UNITED STATES
NUCLEAR REGULATORY COMMISSION
WASHINGTON, D. C. 20555

AMENDMENT TO FACILITY OPERATING LICENSE

Amendment No. 106
License No. DPR-51

SAFETY EVALUATION BY THE OFFICE OF NUCLEAR REACTOR REGULATION

FIGURE 4.18.1

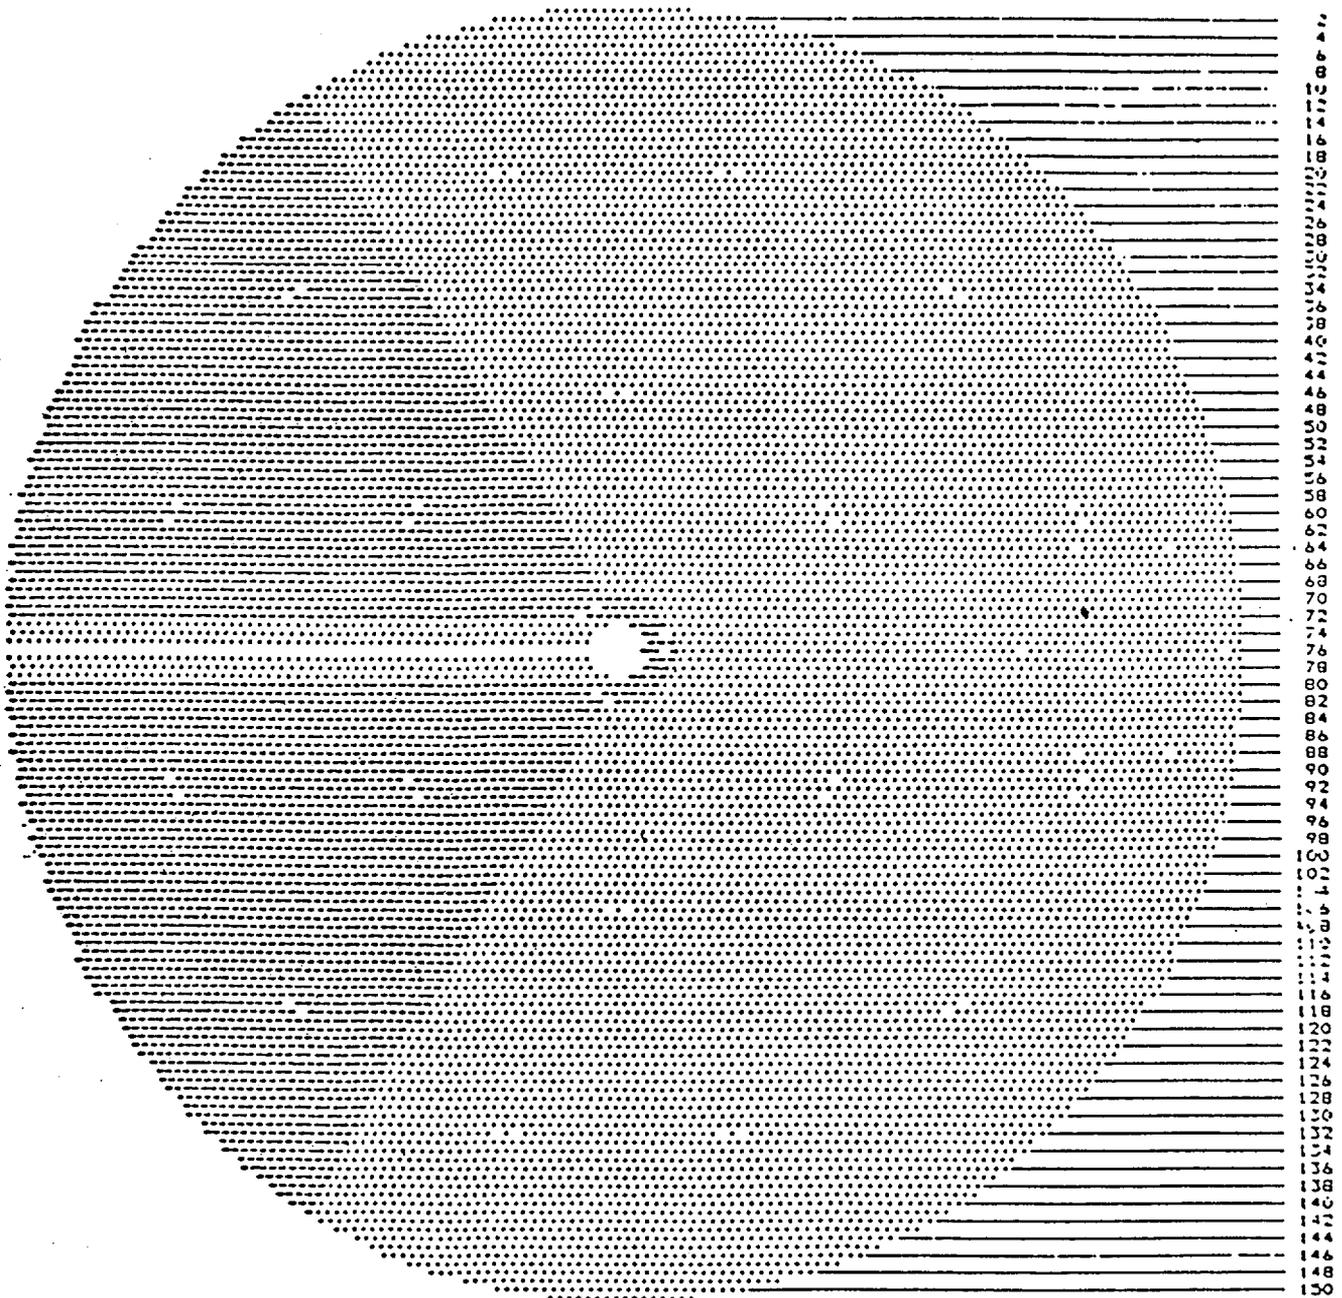
(1) Group A-1: Tubes within one, two or three rows of the open inspection lane.

(3) Group A-3: Tubes in the wedge-shaped group on either side of the lane region (Group A-1) as defined by Figure 4.18.1.
